DESIGN STANDARDS BULLETIN

ODU DEPARTMENT: Facilities Management | Risk Management

Appendix M – Building Signage

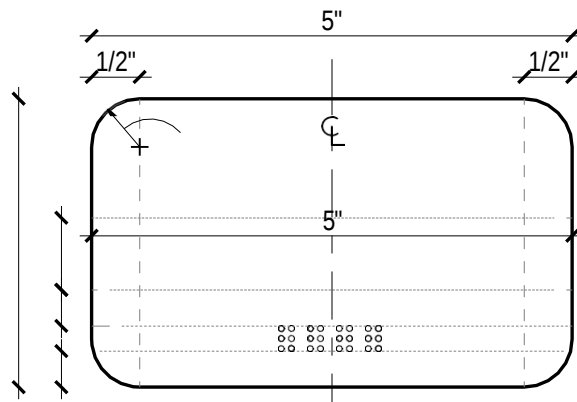
Signage in the exit stairwells, Sign Type K was incorrect per the current code.

Revise sign types J, K and K.1 per the attached.
